**Re: ERO 025-0347 Request for an Amendment to Minister's Zoning Order,  
Ontario Regulation 10/24, City of Toronto**

# Toronto H1 Heliport Hospital Study

## Sick Kids Eastern Flight Path

# OPTION 2 - Alternate Flight Path - Minimum Required H1 Helipad Flightpath + H2/H3 OLS

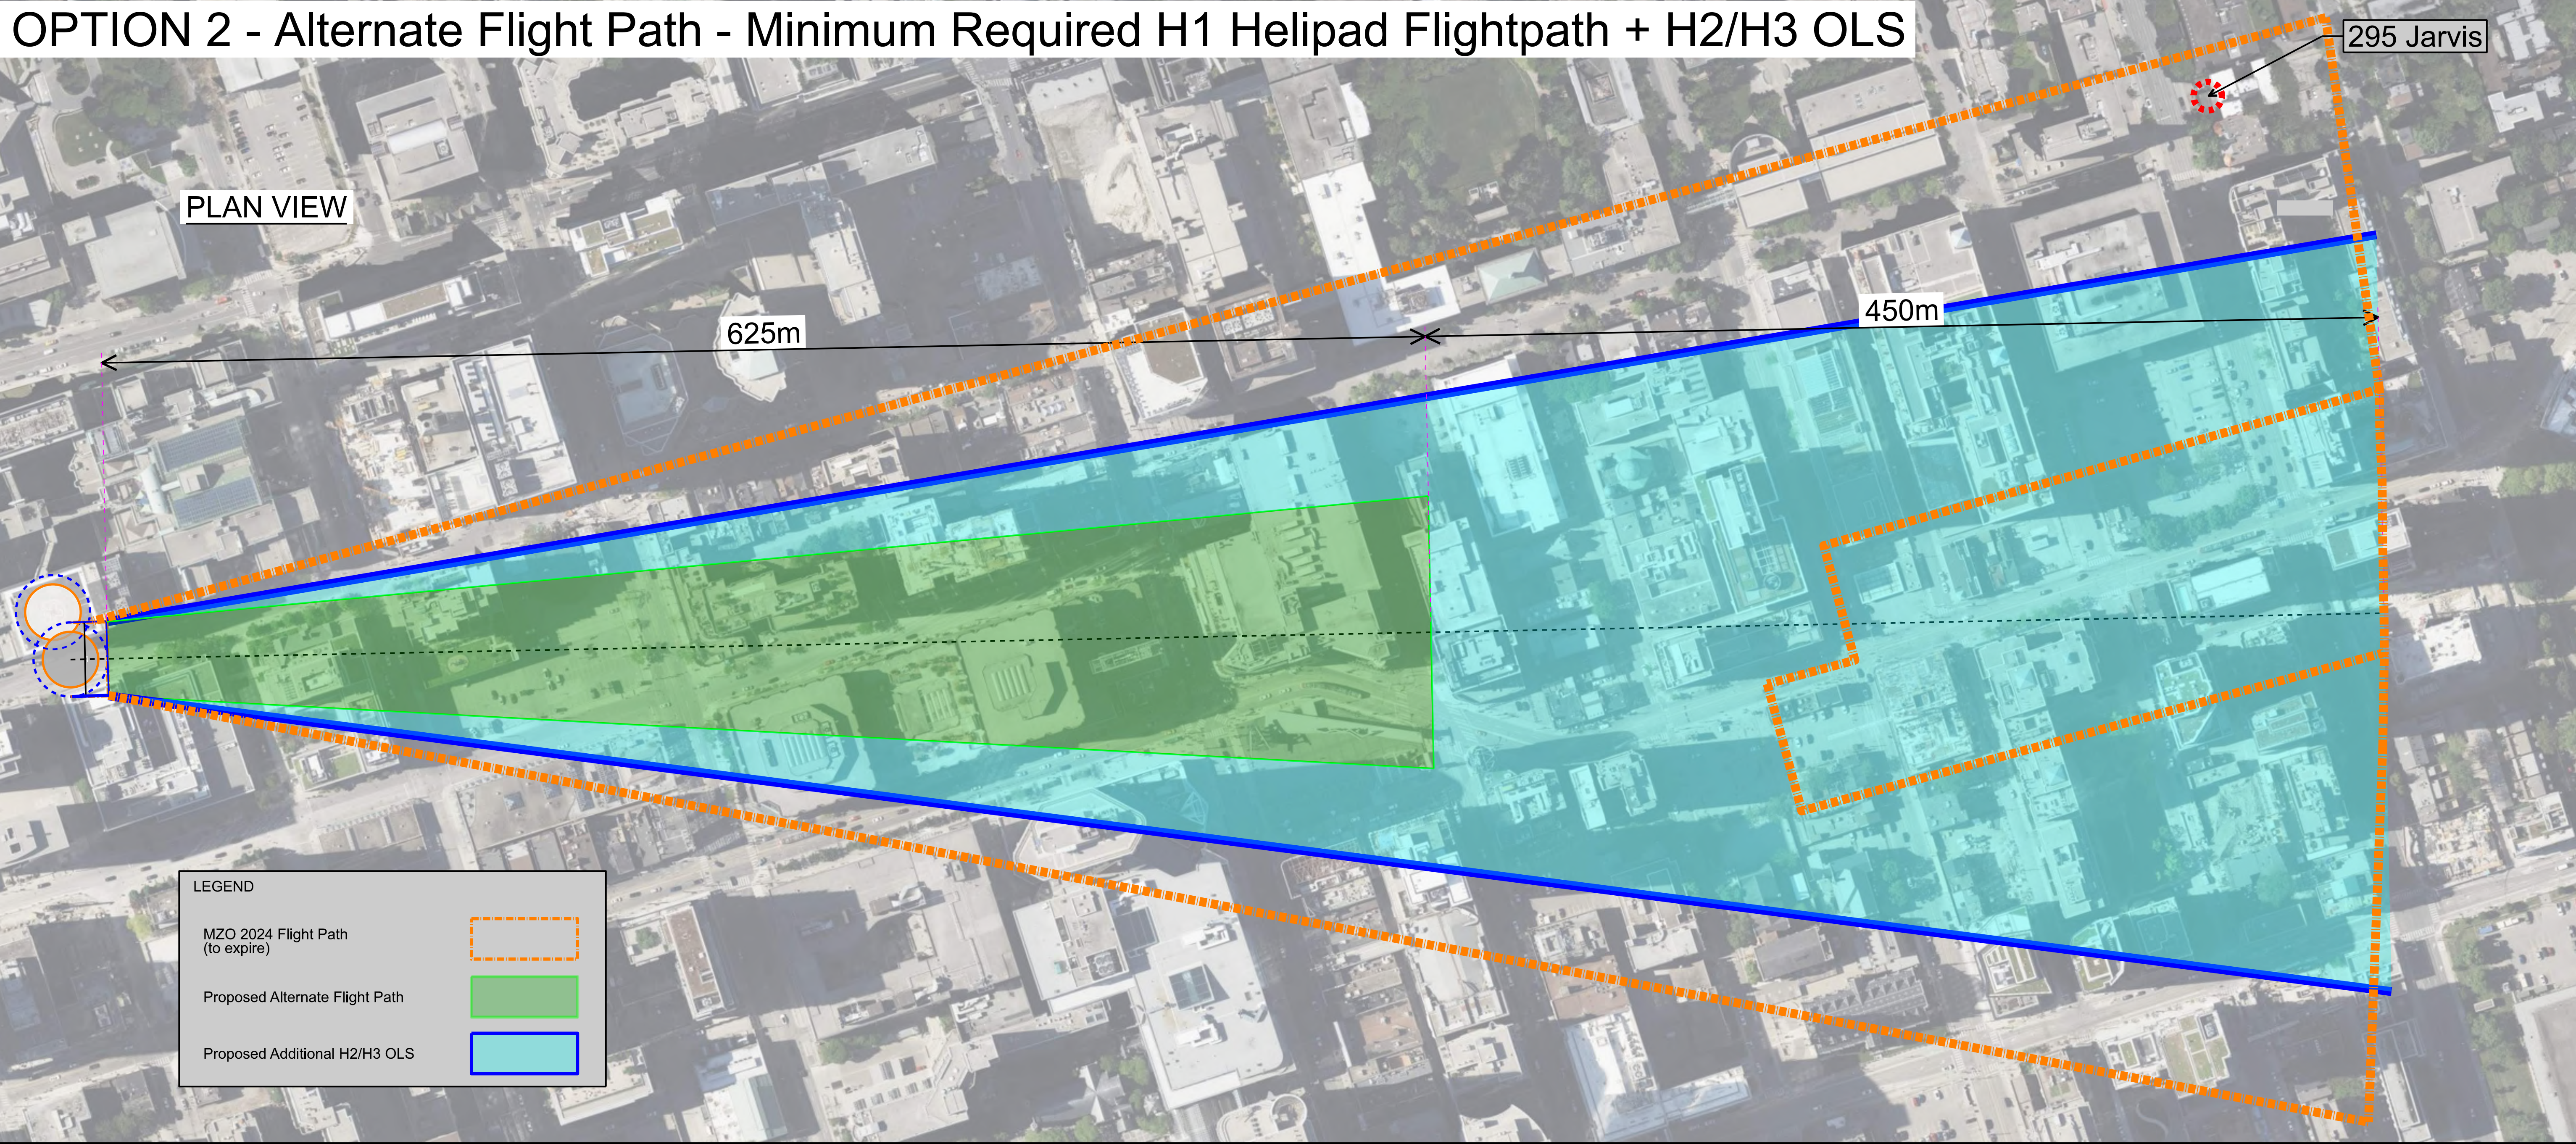
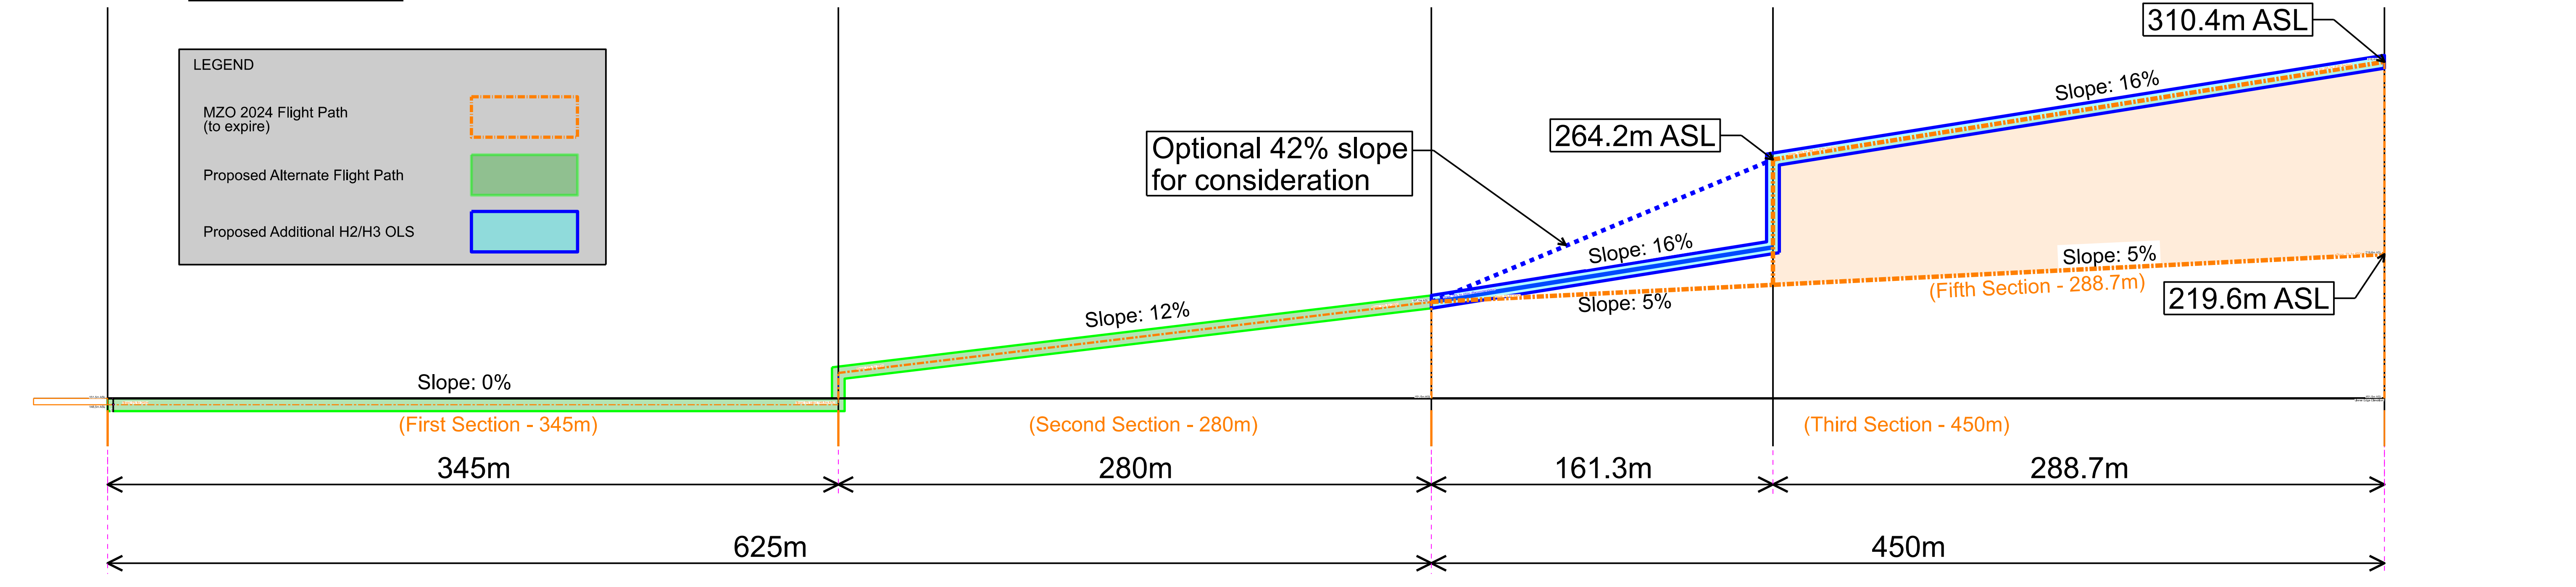
The blue areas outside of the green H1 quadrilateral area (as shown in Appendix F and Appendix G), are a recommendation that can be used to control development outside of the H1 flight path. These blue areas would be designed according to Transport Canada Standard 325, section 325.29, Table 4-1.

Appendix F, presented as Option 2, covers less area than Appendix G (Option 3) because it is more aligned with Table 4-1 with a 15% divergence used as the outer lateral boundaries. Appendix G (Option 3), on the other hand, occupies the largest area as it is based on the total area prescribed by MZO (2024).

Both options 2 and 3 are demonstrating a single 16% sloping surface extending laterally from Section 5 in the MZO (2024) diagram. Having a single sloping OLS surface on each side of Section 5 would be considered a safer procedure rather than having vastly different elevations (section 5 vs section 3) within a flight path.

As shown in both options 2 and 3, consideration should be given to eliminating the abrupt elevation change from the end of the H1 quadrilateral area to the beginning of the proposed Section 5 surface. If helicopter performance allows, a 42% sloping surface can join these 2 areas thereby keeping a smooth, uniform flight path surface as all OLS surfaces should be.
